Re: City of Wichita Falls- PWS ID No. 2430001
Temporary Direct Potable Reuse Project
Response to Conditional Approval Letter (9/5/2013)

September 5, 2013 Conditional Letter of Approval Comments:

TEMPORARY DIRECT POTABLE
REUSE CONVEYANCE FACILITIES
CITY OF WICHITA FALLS, TEXAS

EXISTING 42\" FROM 2010 TRANSFER PUMPS CONNECTION - PLAN
1\" = 30'-0\"

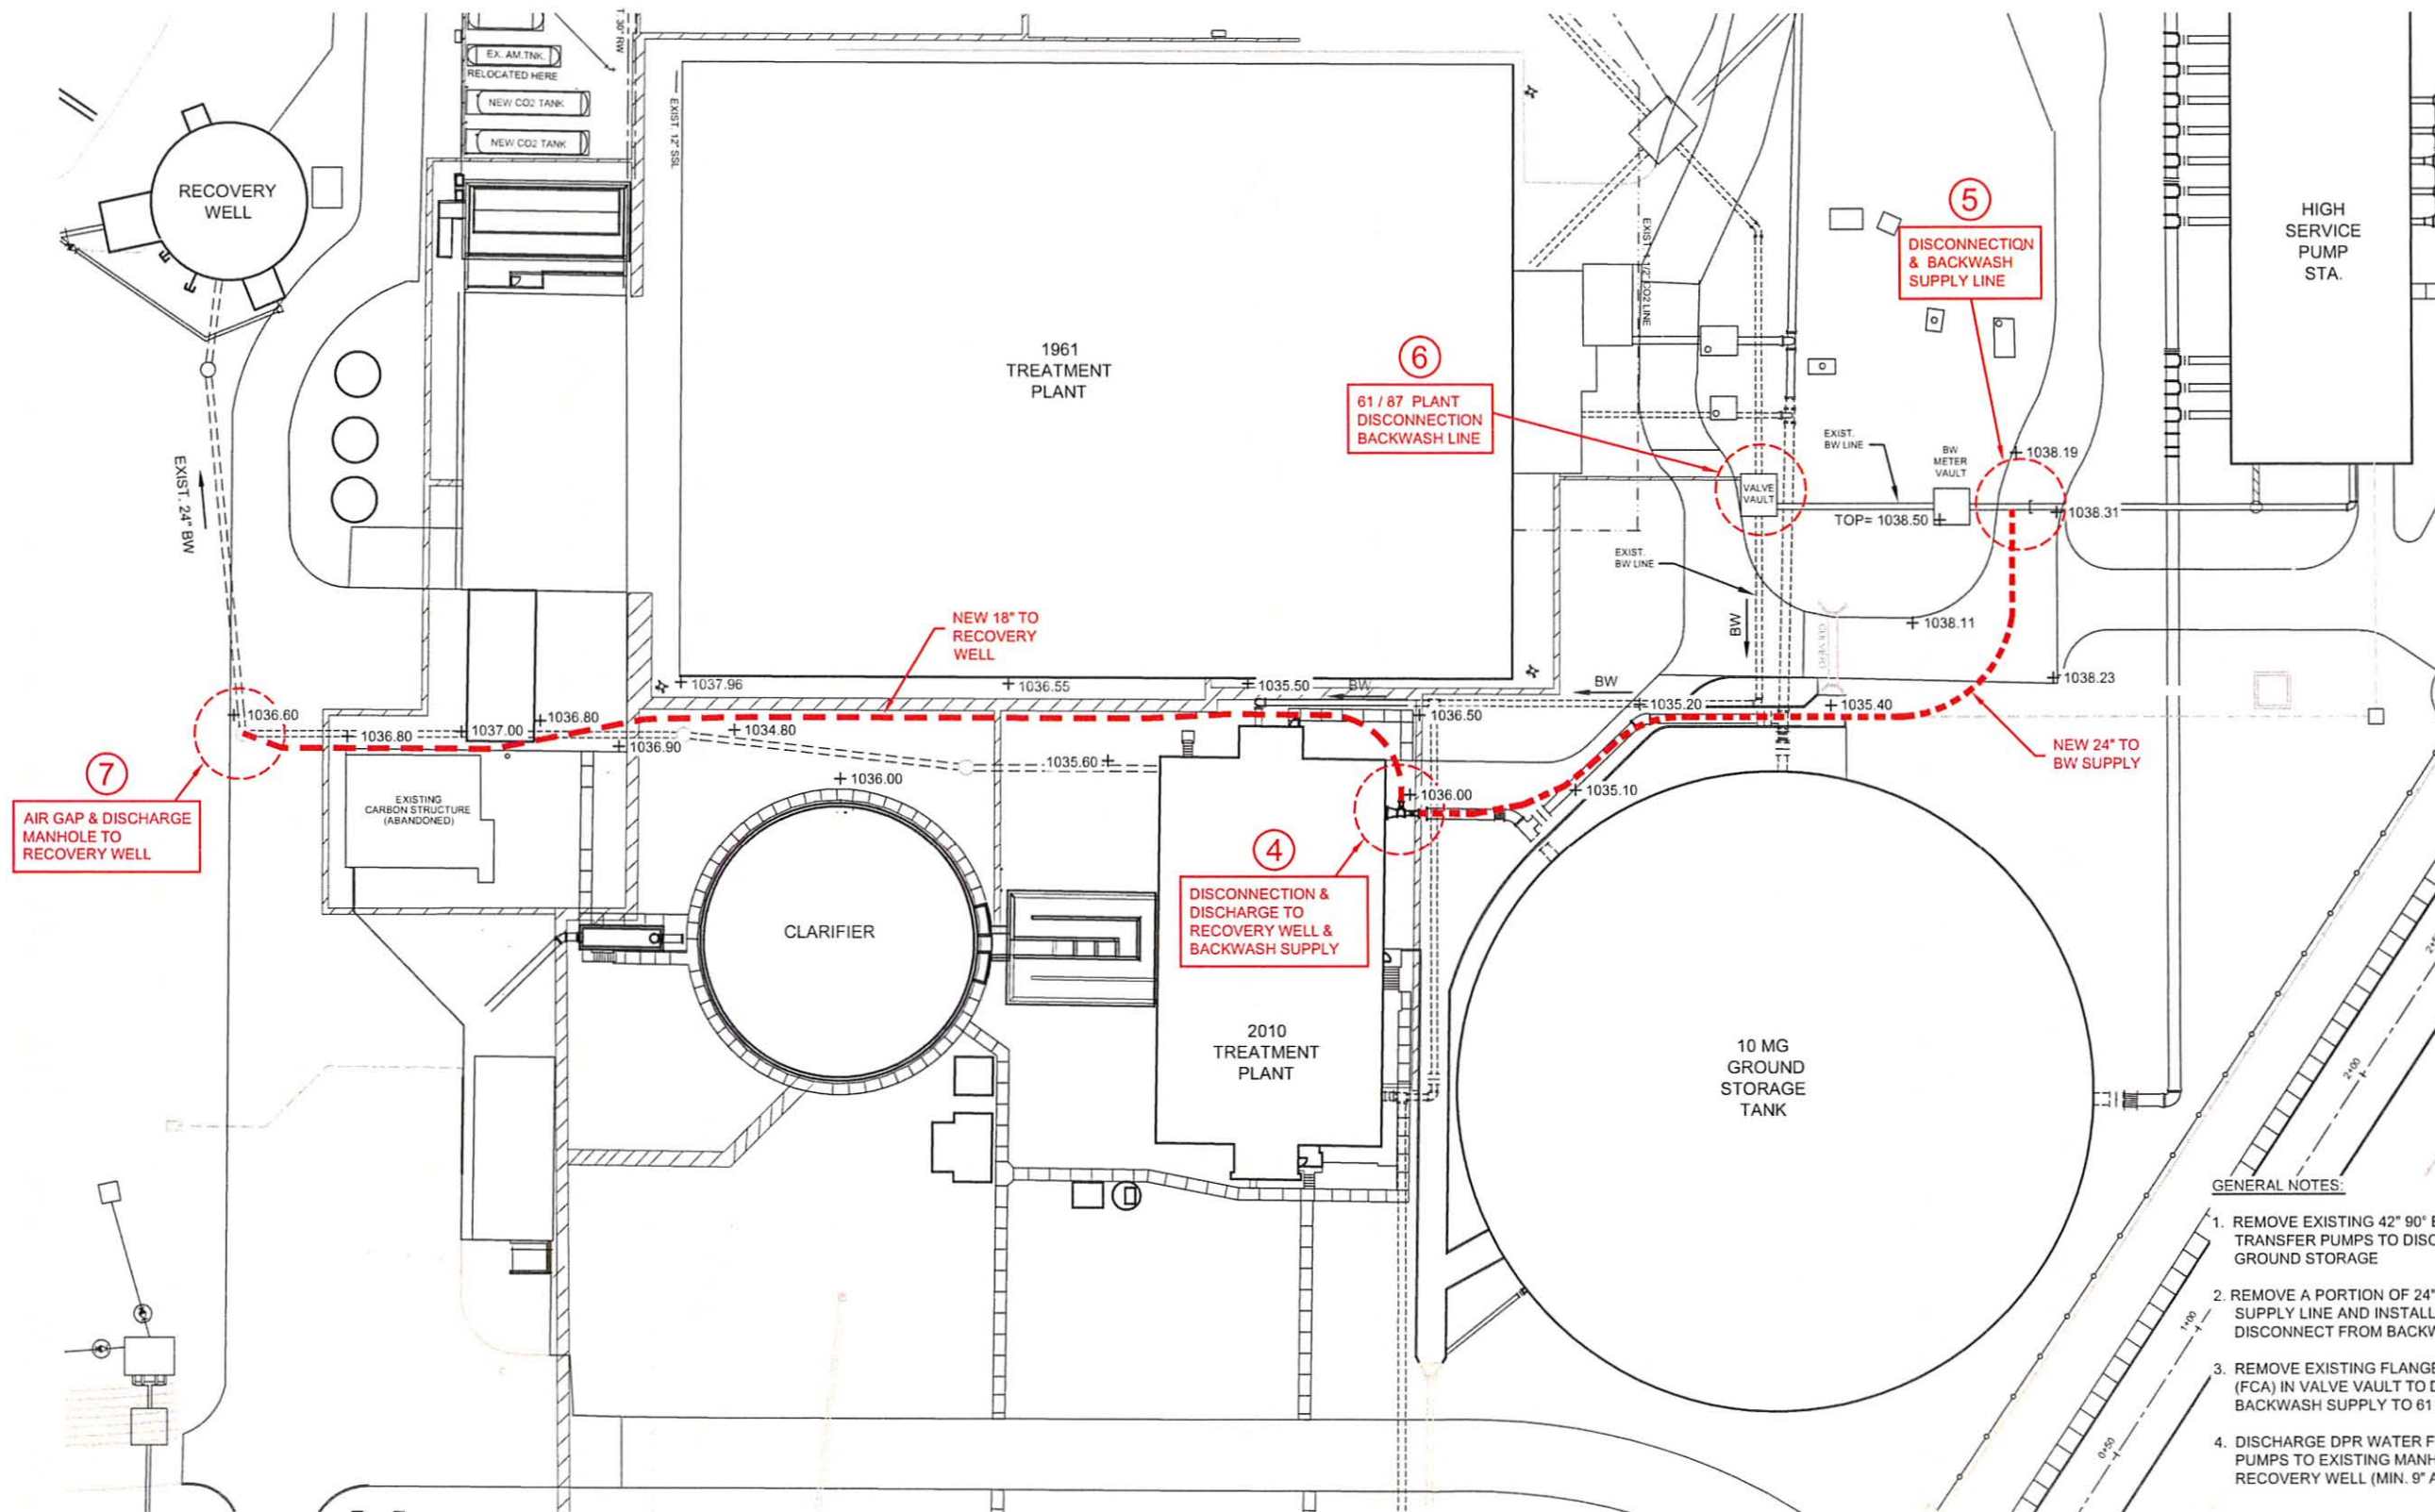
4. **Page 9 Item 12g:** The TCEQ will require the existing backwash supply line be disconnected from the existing backwash pumps during the verification testing. In addition, TCEQ will require the City to backwash the DPR filters with the treated effluent water from the 2010 clearwell. In order to meet these requirements, the City intends to utilize the 2010 transfer pumps for backwash in lieu of the existing backwash pumps located in the High Service Pump Station. In addition, as requested, the City will disconnect the backwash line coming from the existing High Service Pump Station. Finally, for your review and consideration, we have included three (3) sheets of drawings that we believe complies with the backwash supply requirements set forth by TCEQ.

Action: The City request approval of the attached temporary backwash supply drawings.
